SAFEWAY SHOPPING CENTER – COLLEGE AND CLAREMONT AVENUES

Response to Comments and Final Environmental Impact Report
File No. ER09-0006
State Clearinghouse # 2009112008
 2009102100

July 2012

COLLEGE AVENUE SAFEWAY PROJECT NOTICE OF RELEASE AND AVAILABILITY OF RESPONSES TO COMMENTS AND FINAL ENVIRONMENTAL IMPACT REPORT (FEIR)

Revised Project Access Option 1 Figure 2-1

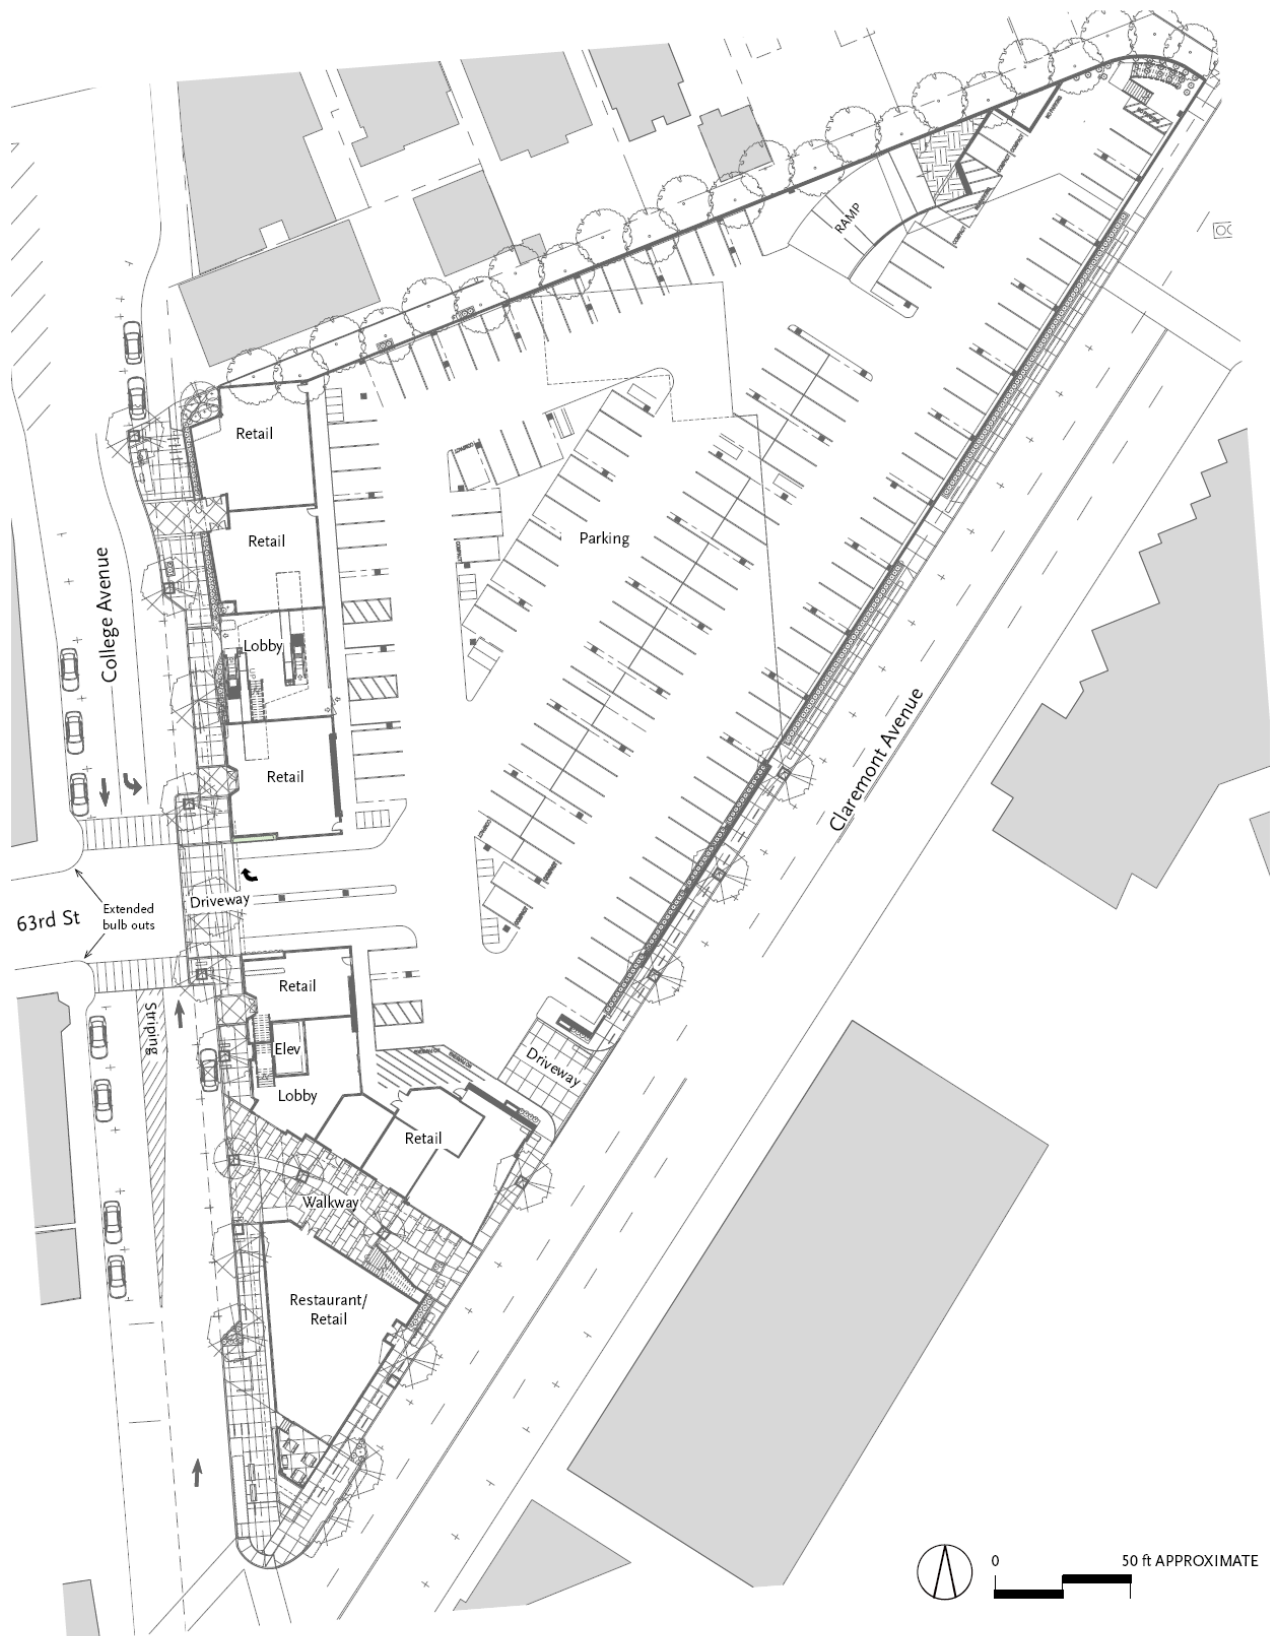
The revised project includes the following modifications to the store driveway and street configuration at the intersection of 63rd Street and College Avenue (see Figures 2-1 and 2-2):

- Option 1, as shown on Figure 2-1, would construct a median on College Avenue to physically prevent automobiles from completing the prohibited movements. The median cannot be wider than six feet in order to allow trucks to turn right from northbound College Avenue to the project driveway and from eastbound 63rd Street to southbound College Avenue. This option would prevent the installation of bulbouts on the west side of College Avenue as included in Mitigation Measure TRANS-17A. However, the median on College Avenue would provide a refuge for pedestrians crossing College Avenue on the south side of 63rd Street. A disadvantage of this option is that if an automobile is stopped in the travel lane adjacent to the medians to pick-up/drop-off passenger, wait for a parking space, or other reasons, it would block and delay through traffic as other automobiles would not be able to go around it.

Revised Project Access Option 2 Figure 2-2

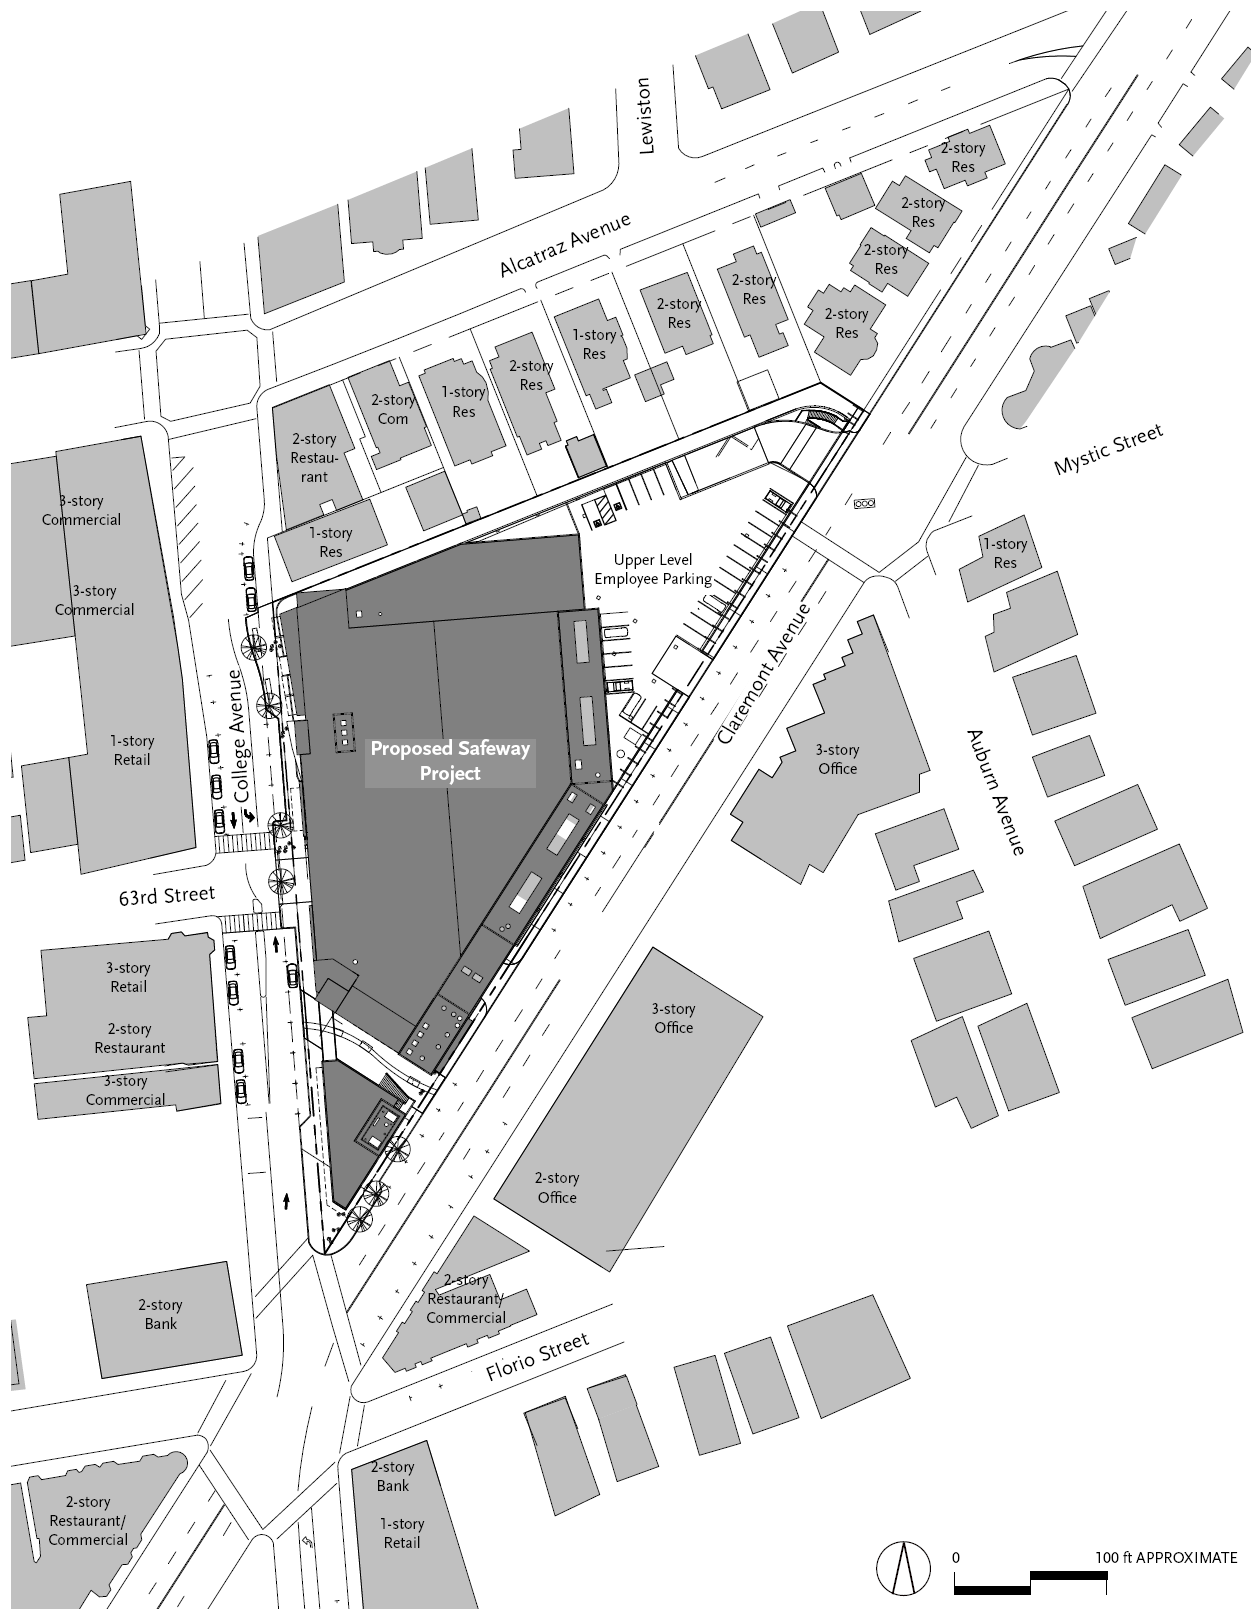
- Option 2, as shown on Figure 2-2, would not construct a physical median but would enforce the prohibited movements through signs and striping. This option would not be as effective as Option 1 in enforcing the prohibited movements. However, it would allow installation of bulbouts on the west side of College Avenue as contemplated in Mitigation Measure TRANS-17A. In addition, stopped automobiles would not block through traffic.

Revised Project Site Plan Figure 2-3

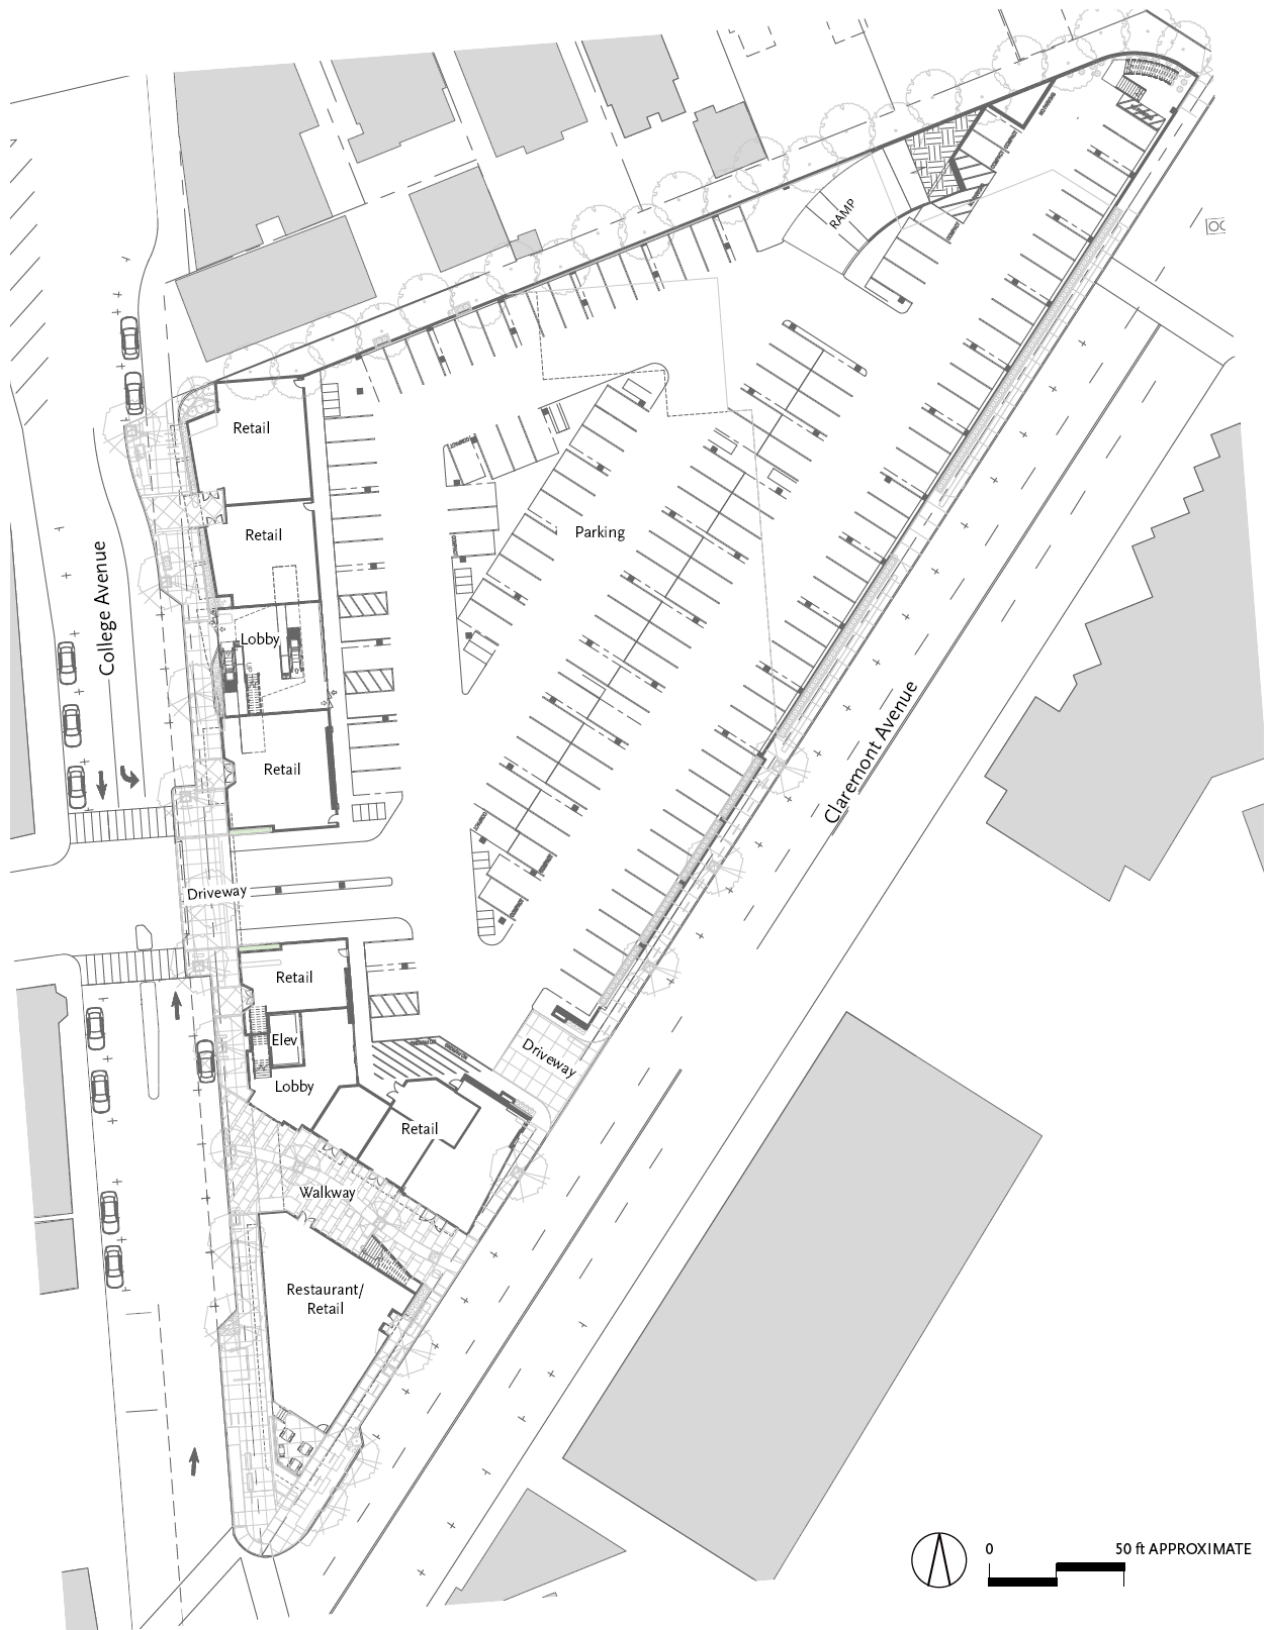
As shown on the revised project site plan on Figure 2-3, the project currently proposes high-visibility crosswalks, as suggested in the comment, on both north and side crossings of College Avenue at 63rd Street. The type of crosswalk and other detailed design features will be considered as part of the final improvements designs at the intersection. The City will consider this input prior to finalizing the intersection design.

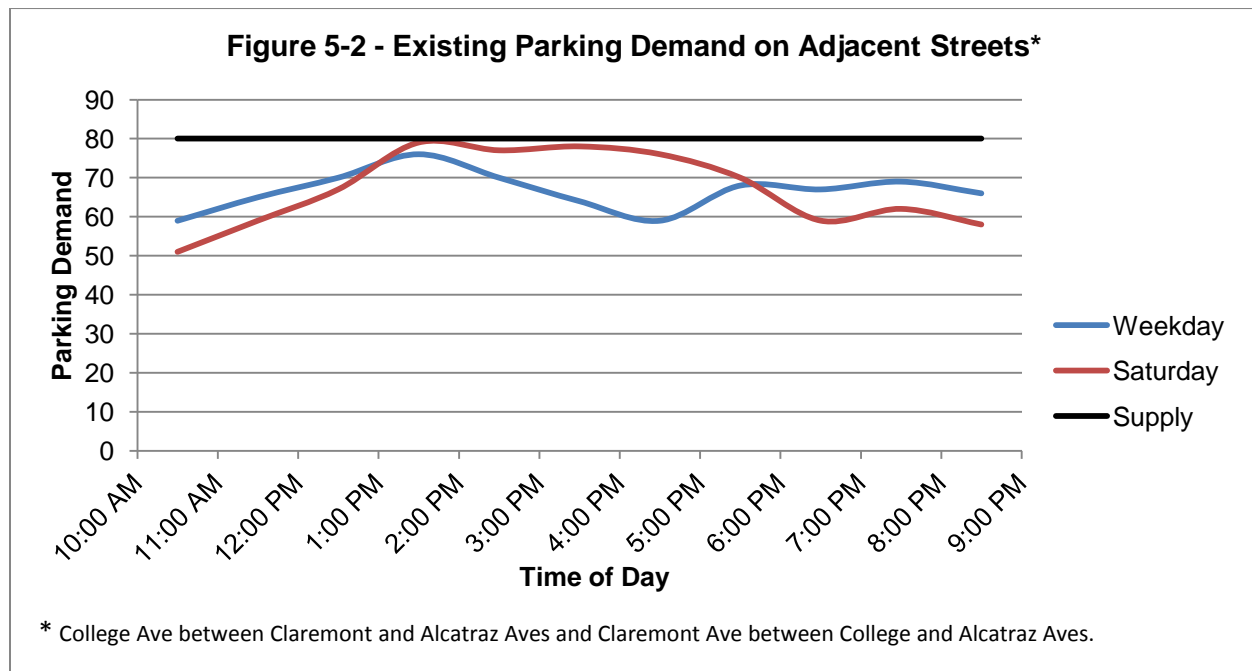
Figure 5-2 summarizes the hourly parking demand on both streets combined for weekday and Saturday conditions between 10:00 AM and 9:00 PM. Parking demand on both weekdays and Saturdays peaks at about 1:00 PM with about 95 percent of spaces occupied on weekdays and almost all spaces occupied on Saturdays. Parking occupancy decreases throughout the afternoon on both weekdays and Saturdays with parking occupancy at about 85 percent on weekdays and 75 percent on Saturdays after 6:00 PM. In general, most of the parking spaces available in the evening are the unrestricted spaces on Claremont Avenue.

College and Claremont Avenues adjacent to the project site currently have about 13 weekday and 21 Saturday spaces available during the PM peak hour (6:00 PM) (see Figure 5-2). Considering that these spaces are most likely to be used by the project parking deficit that cannot be accommodated on-site, the proposed project is estimated to have an unmet demand of 42 parking spaces during the weekday peak hour and 50 spaces during the Saturday peak hour.

Figure 5-6 Existing Store Floor Area

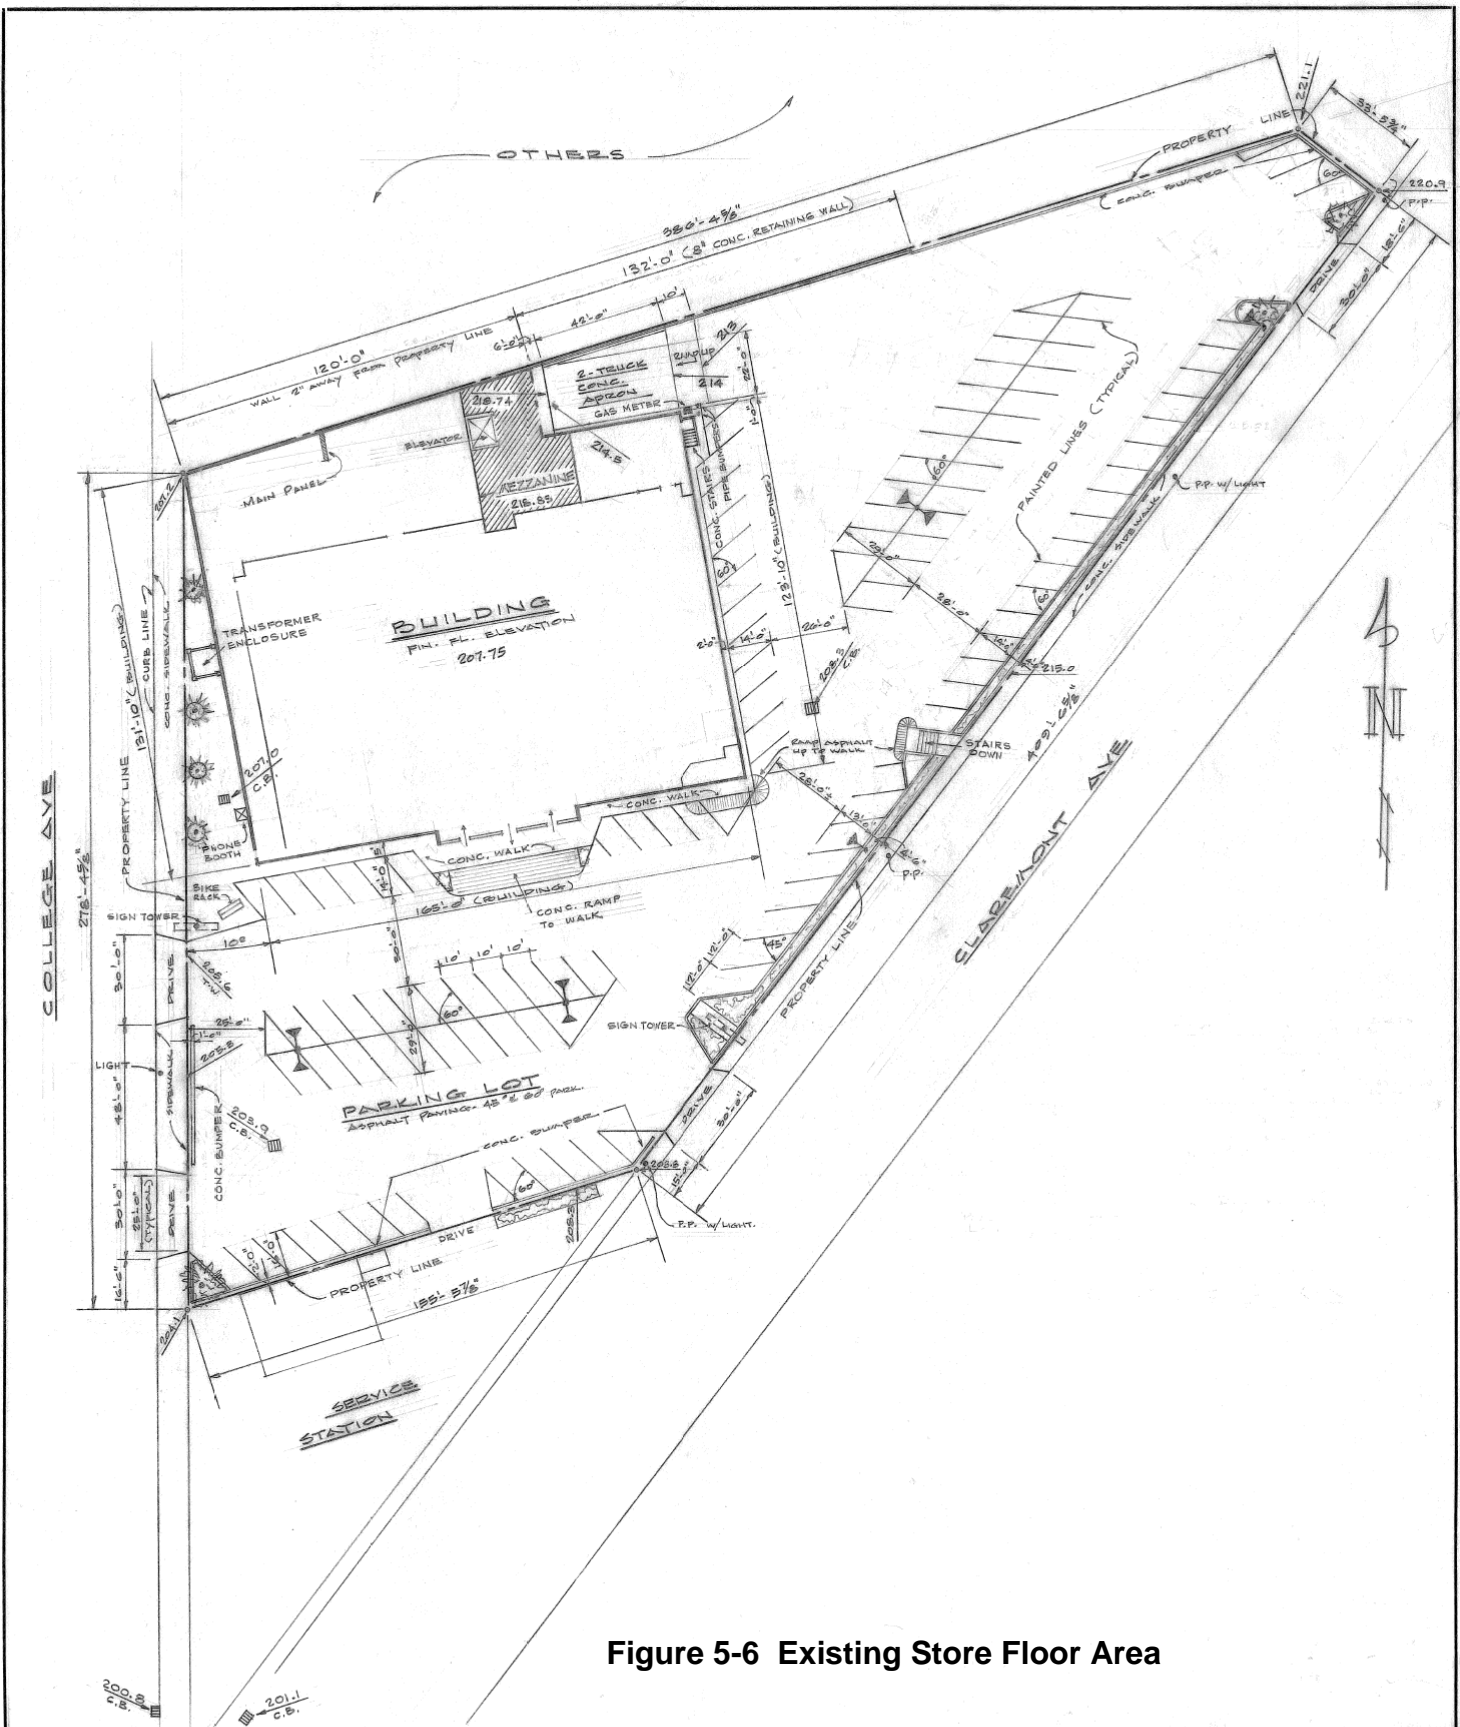
The existing store has been determined by the Safeway architects to be approximately 24,260 square feet, according to industry standard measurements. As shown in Figure 5-6, the salesroom is about 15,238 square feet, the stockroom is about 7,256 square feet, the loading dock is about 143 square feet,
